PRINTWORKS

STUDENT ACCOMMODATION SCHEME

PRINT-1000-ZZ-ZZ-RP-0002

NMA 2: DESIGN AND ACCESS STATEMENT ADDENDUM

FIGURE 2. Proposed Scheme - Printworks L00 UKPN

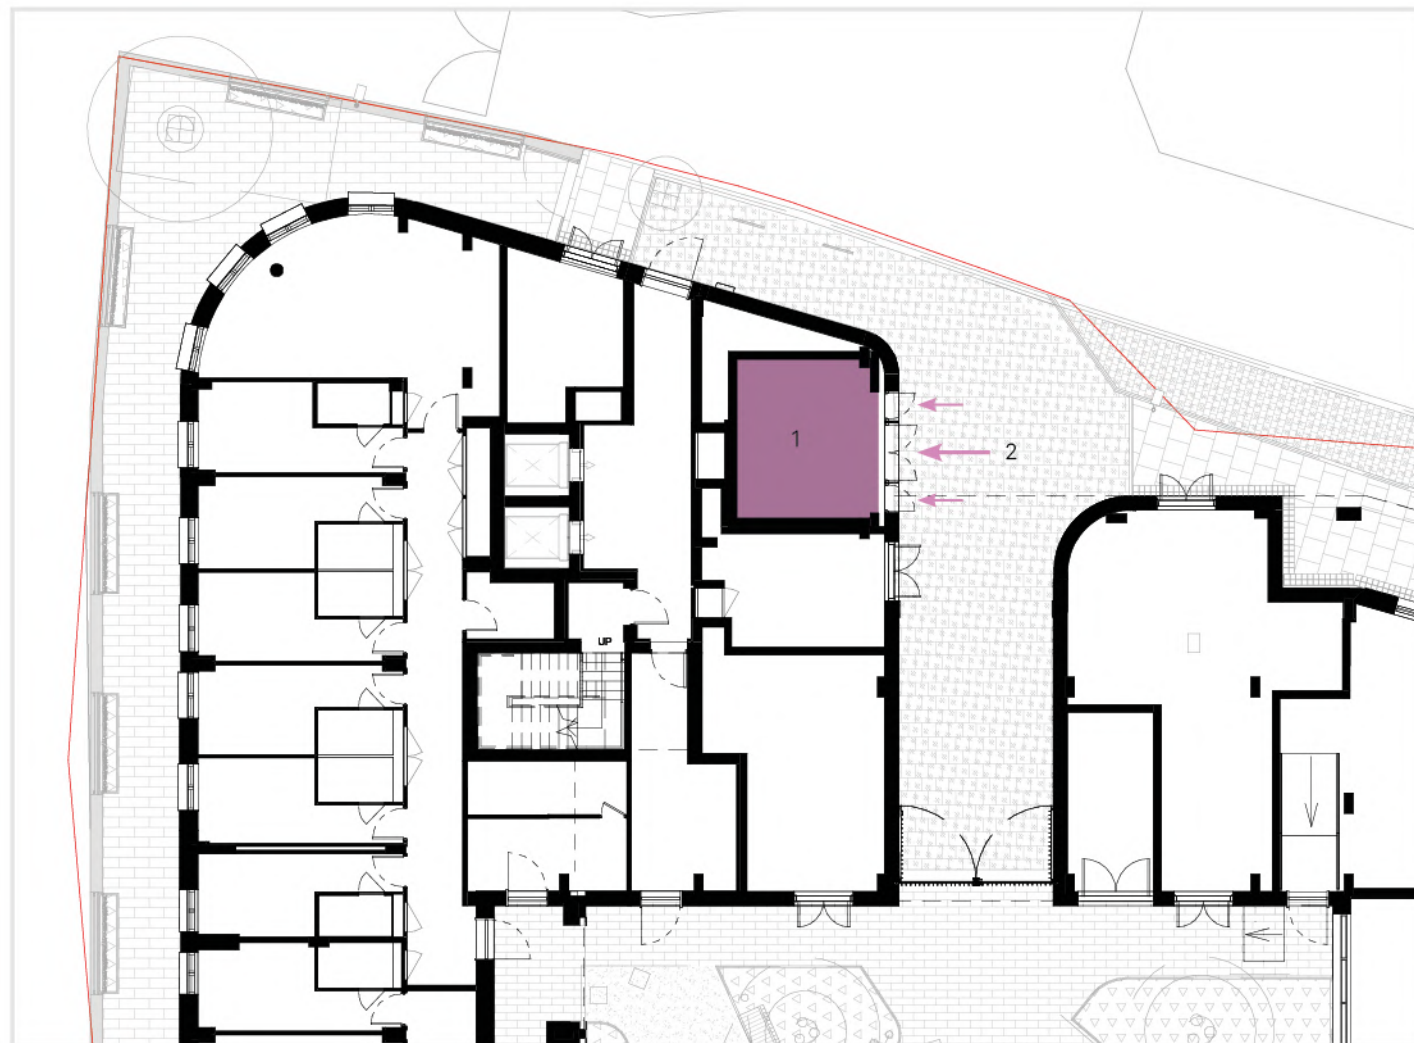
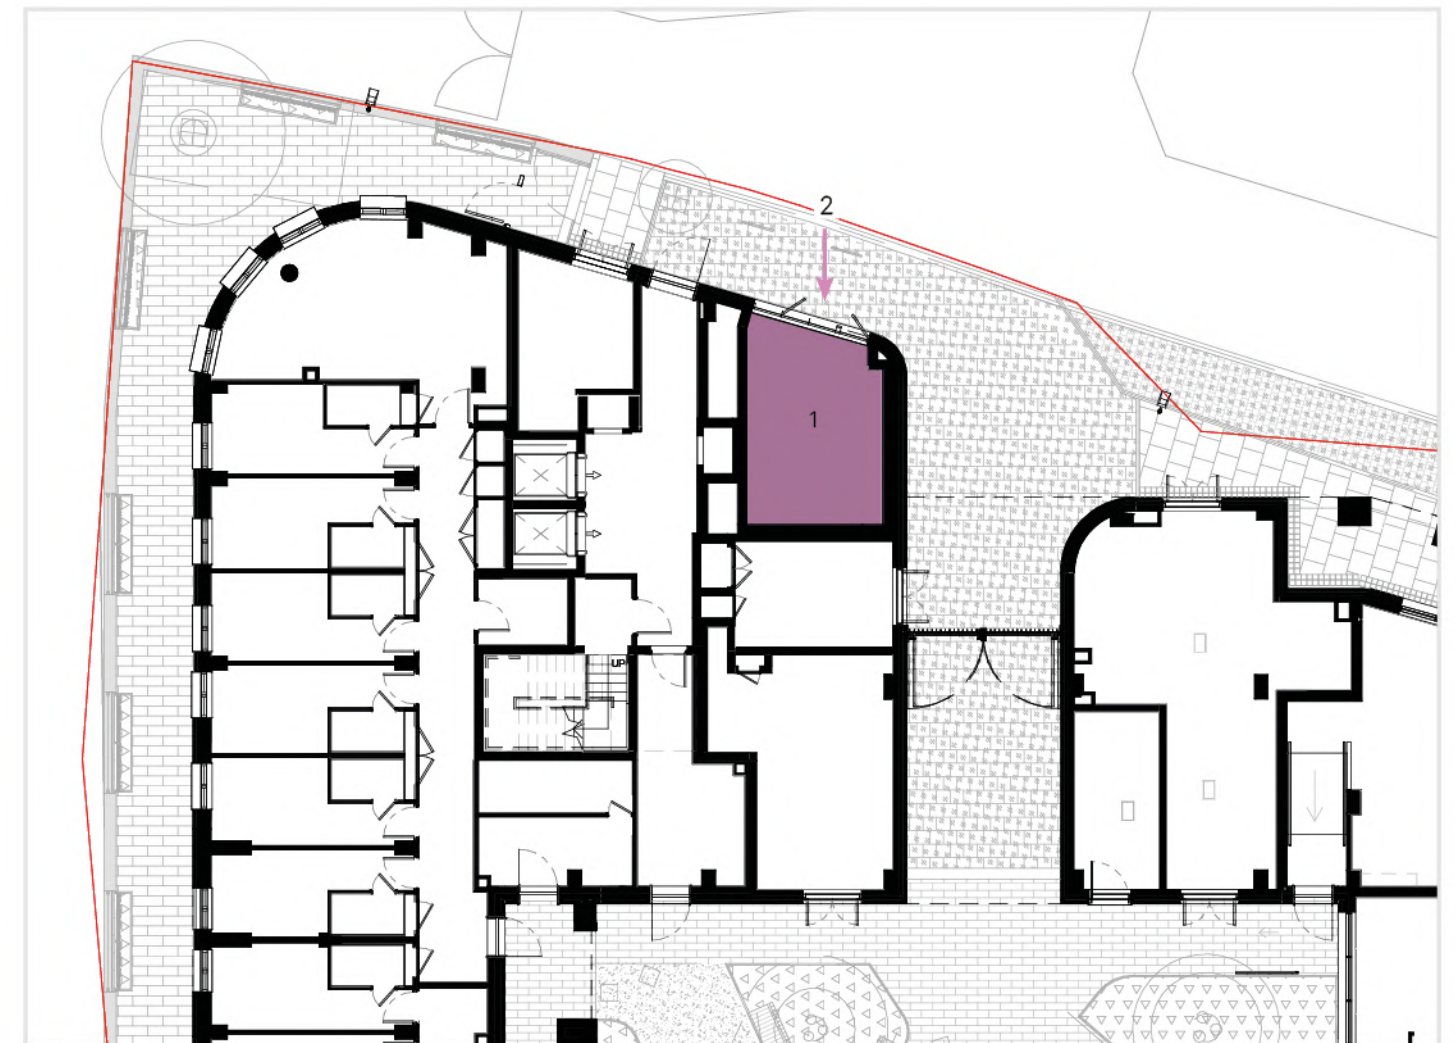
1. Substation
2. The substation entrance doors have been relocated from the eastern to the northern elevation to comply with UK Power Networks (UKPN) safety requirements. UKPN has confirmed that doors opening directly into areas of vehicular movement are not permitted and must be recessed by a minimum of 1 metre from the building frontage. In the eyes of UKPN, the original eastern entrance did not meet this requirement due to its proximity to the vehicle access route. Relocating the doors to the northern elevation allows the safe access for maintenance personnel and aligns the layout with UKPN's requirements.

FIGURE 18. Proposed Scheme - Printworks L03

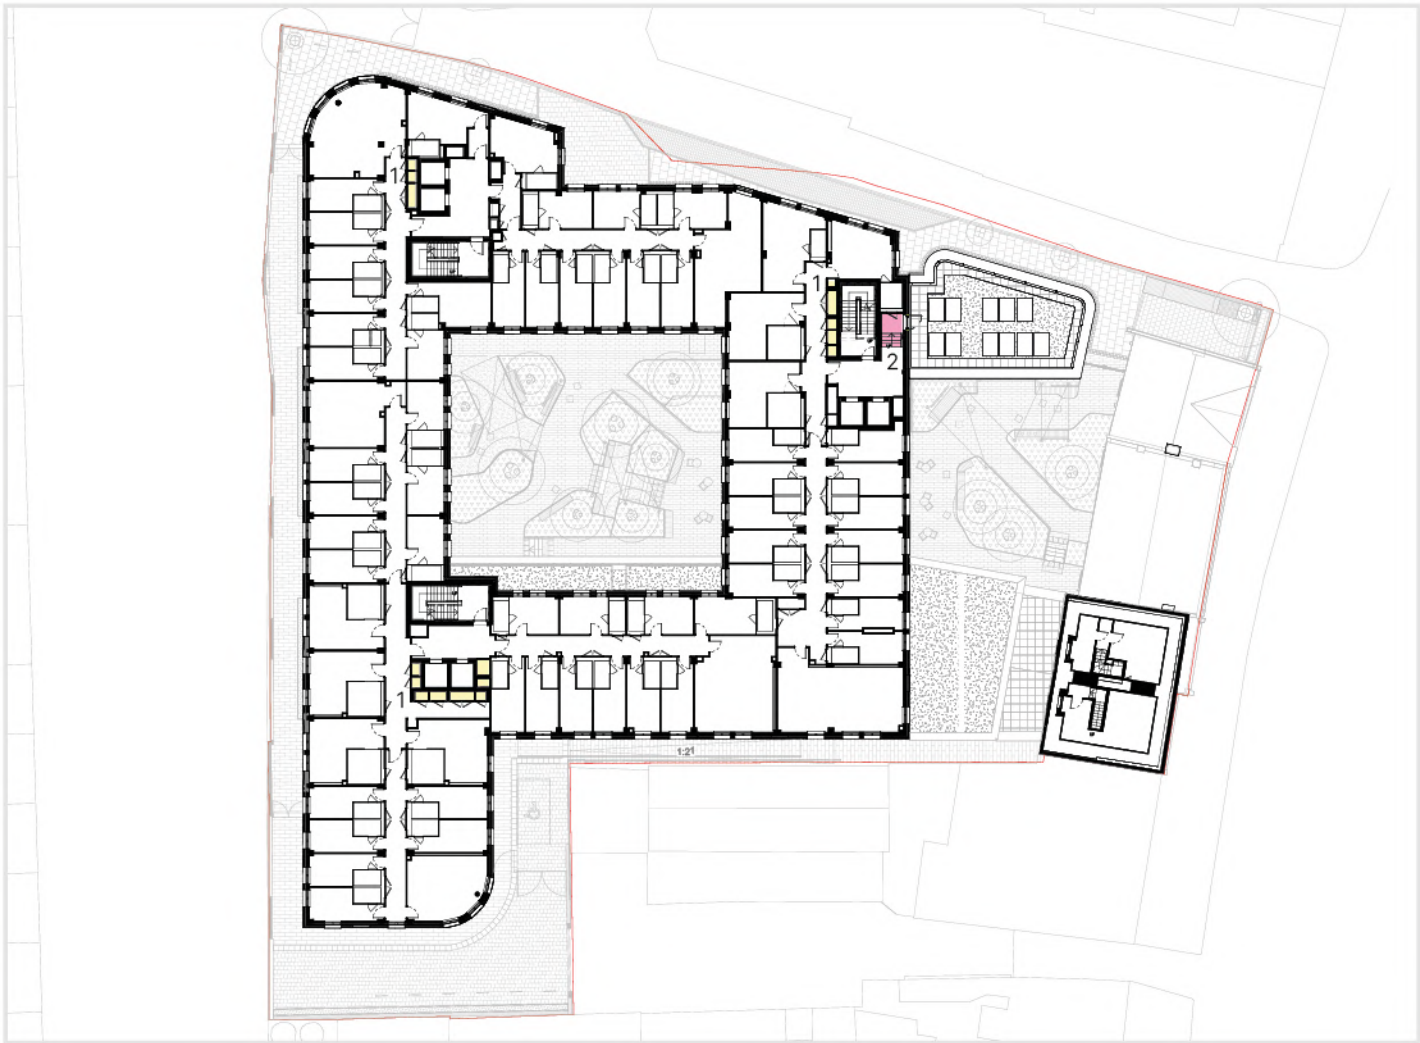
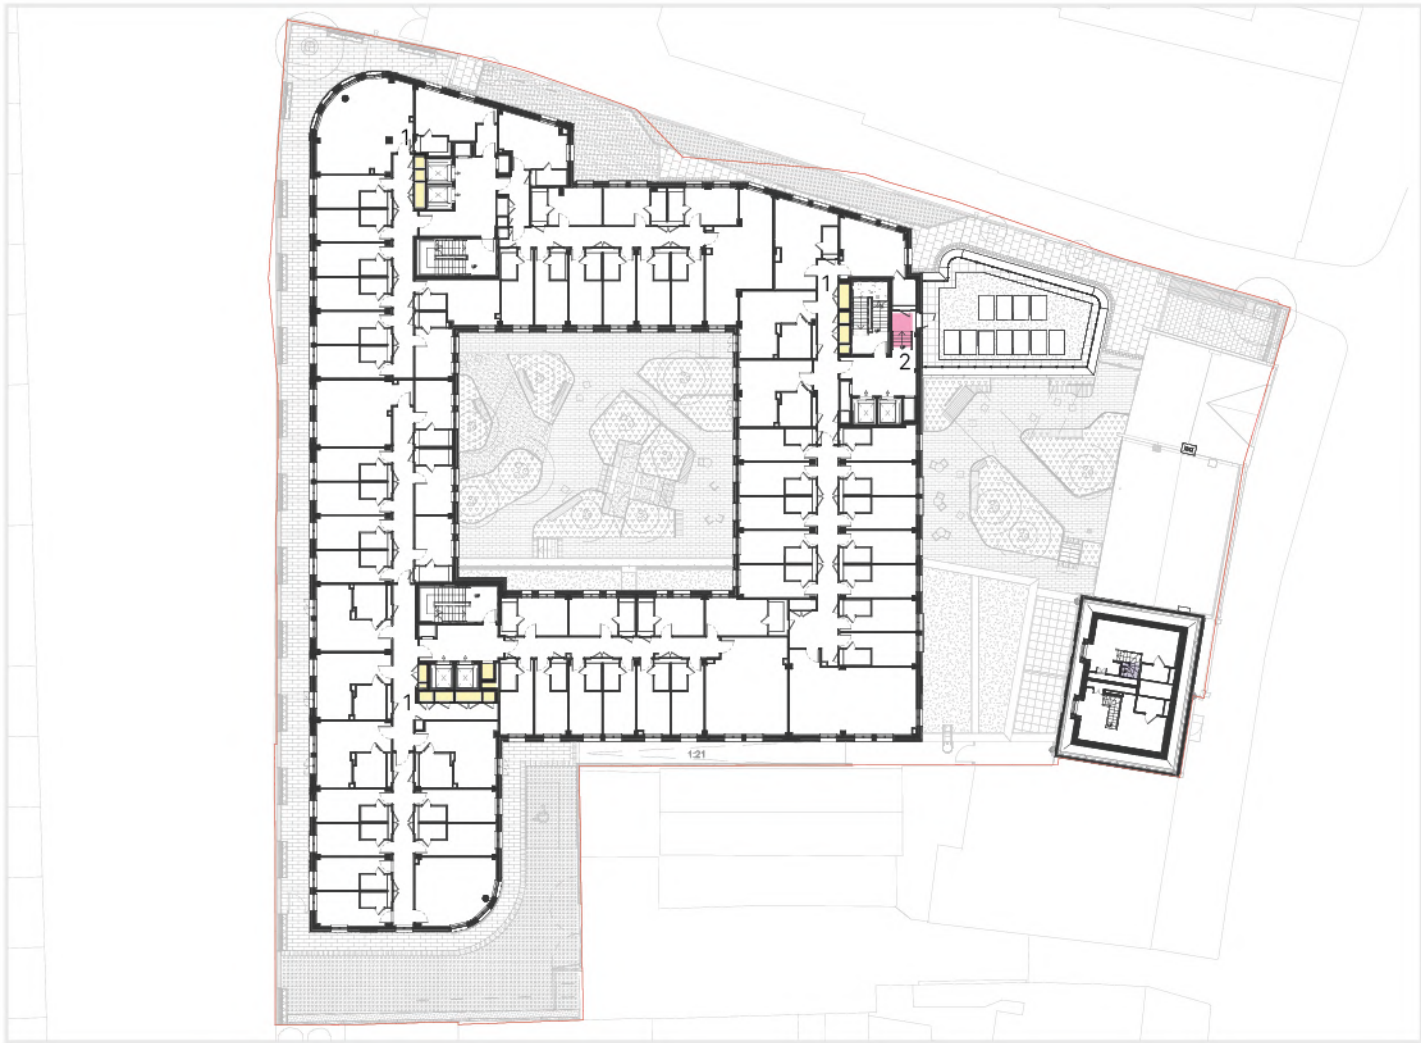
- 1. Adjustments to riser internal separating partitions in cores as response to MEP engineer requirements.
- 2. Minor adjustments to roof maintenance access internal stairs due to design development of interior layout and concrete upstands.
- 3. Stair layout altered following structural development and fire strategy review.

FIGURE 20. Proposed Scheme - Printworks L04

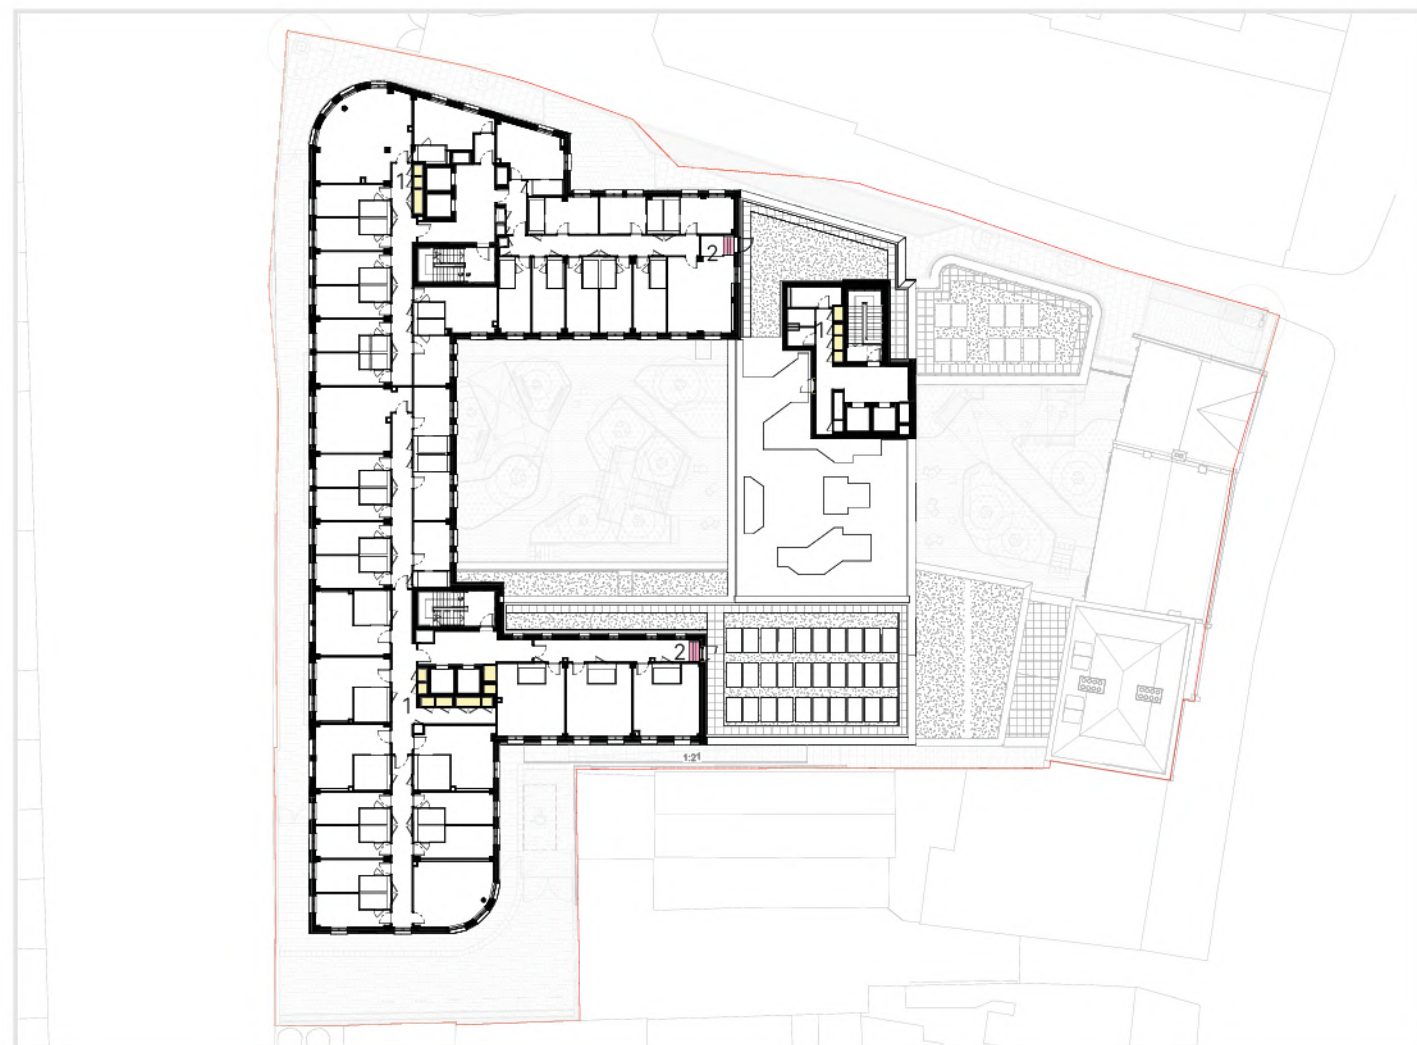
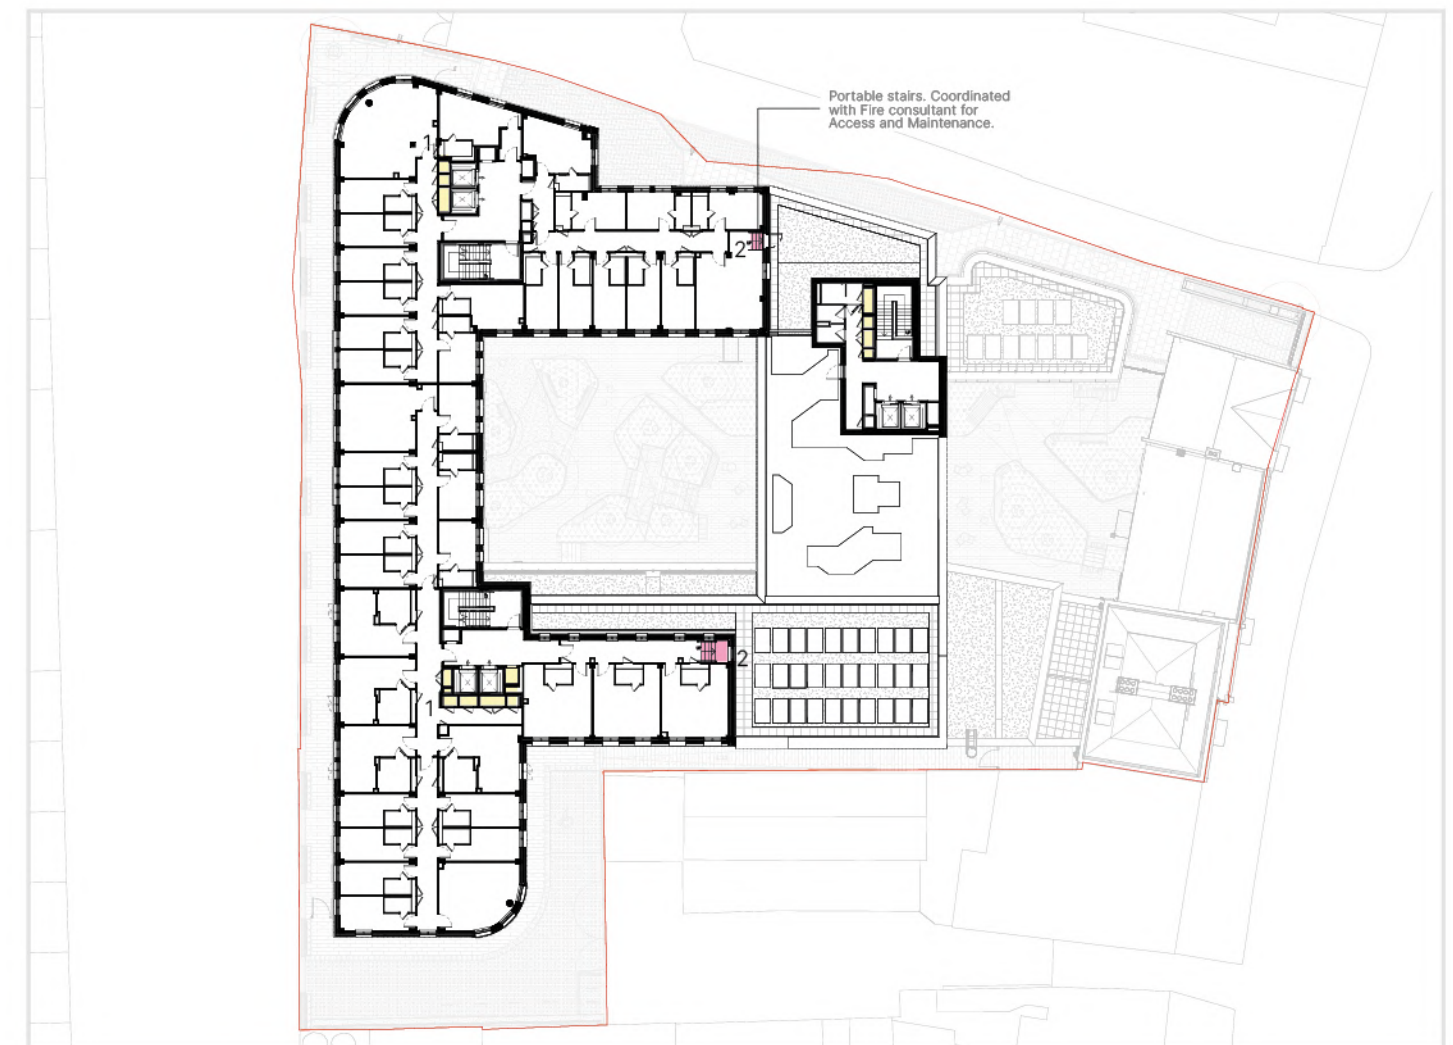
1. Adjustments to riser internal separating partitions in cores as response to MEP engineer requirements.
2. Minor adjustments to roof maintenance access internal stairs due to design development of interior layout and concrete upstands.
